QIA INSPECTION REPORTS AND BAFFINLAND RESPONSE

2021 July Environmental Inspection – Information Request

Emergency Controlled Discharge from MS-08 Investigation and Summary of Findings

Baffinland Response to QIA 2021 July Environmental Inspection Report

Figure 1. Average temperature recorded at various stations between 2014 and 2019. Figure reproduced from Phase 1 Waste Rock Management Plan - Revision 3 Appendix A3.

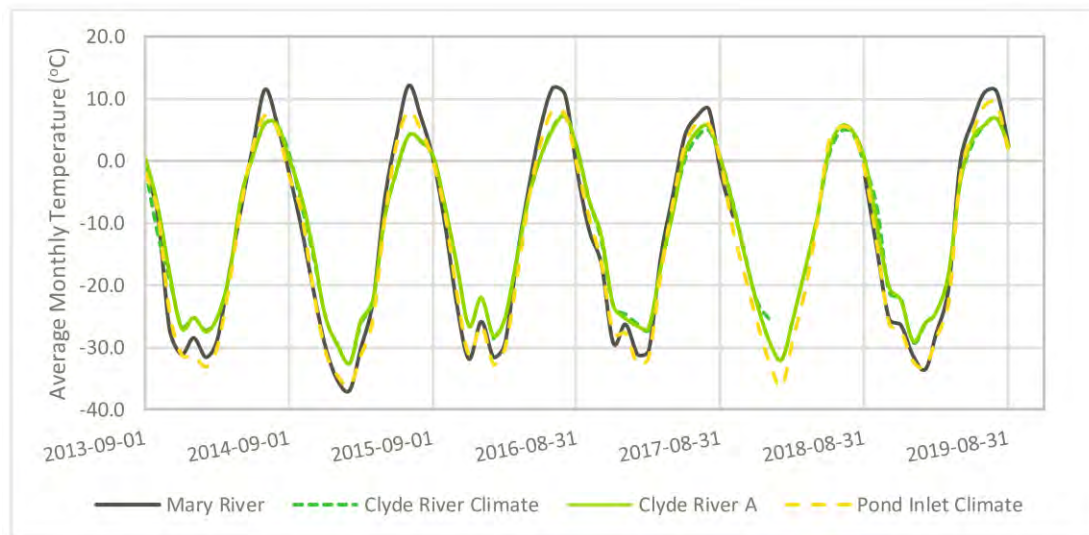
Temperatures measured at Pond Inlet A in winter 2021 were generally warmer than previous years while still remaining predominantly well below freezing (Table 1). May and June (spring), the two months that mostly contribute to the onset of Freshet, were both only around the 75th percentile of measured average monthly temperatures from 2013-2020 (a representation of recent climate data). While the Mary River site is likely to have experienced warmer temperatures, it is unlikely that Spring 2021 represents a significant deviation from recent climate norms. The rate at which the snowpack melted is unlikely to have been substantially higher than in previous years, or have resulted in a more intense Freshet than in the past.

Figure 2. Comparison of concurrent daily and monthly rainfall at Mary River Station and Pond Inlet A between 2014 and 2019. Figure reproduced from Phase 1 Waste Rock Management Plan - Revision 3 Appendix A3.

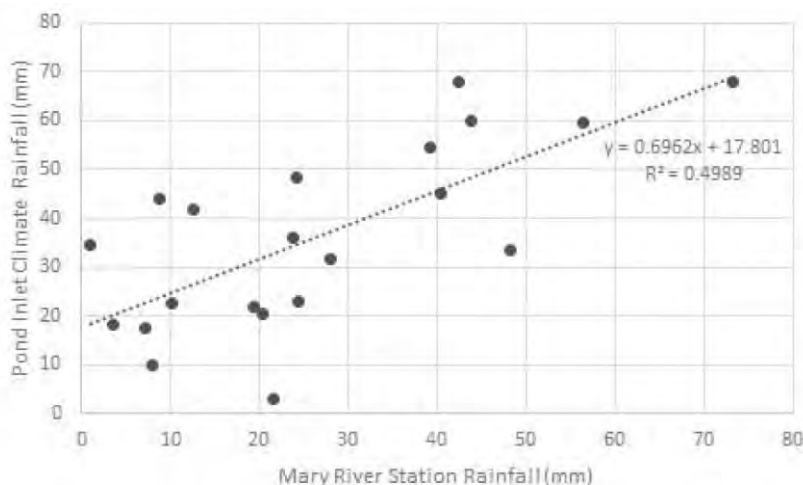
Baffinland indicated that recent precipitation events contributed to the need for the Emergency Controlled Discharge. In the absence of rainfall data available for June 2021, data measured at Pond Inlet A following the precedent set in Baffinland's site Water Balance does not indicate substantially more rainfall than normal, although there is some uncertainty associated with the conclusion. The relationship between rainfall measured at Pond Inlet A and the Mary River weather station is not exceptionally strong; precipitation measurements collected at the two stations have an r^2 of 0.4989 between 2014 and 2019 (Figure 2).

However, Baffinland has used data from the Pond Inlet station as input to their water balance, increasing recorded values by 30% when applied to the Mary River site².
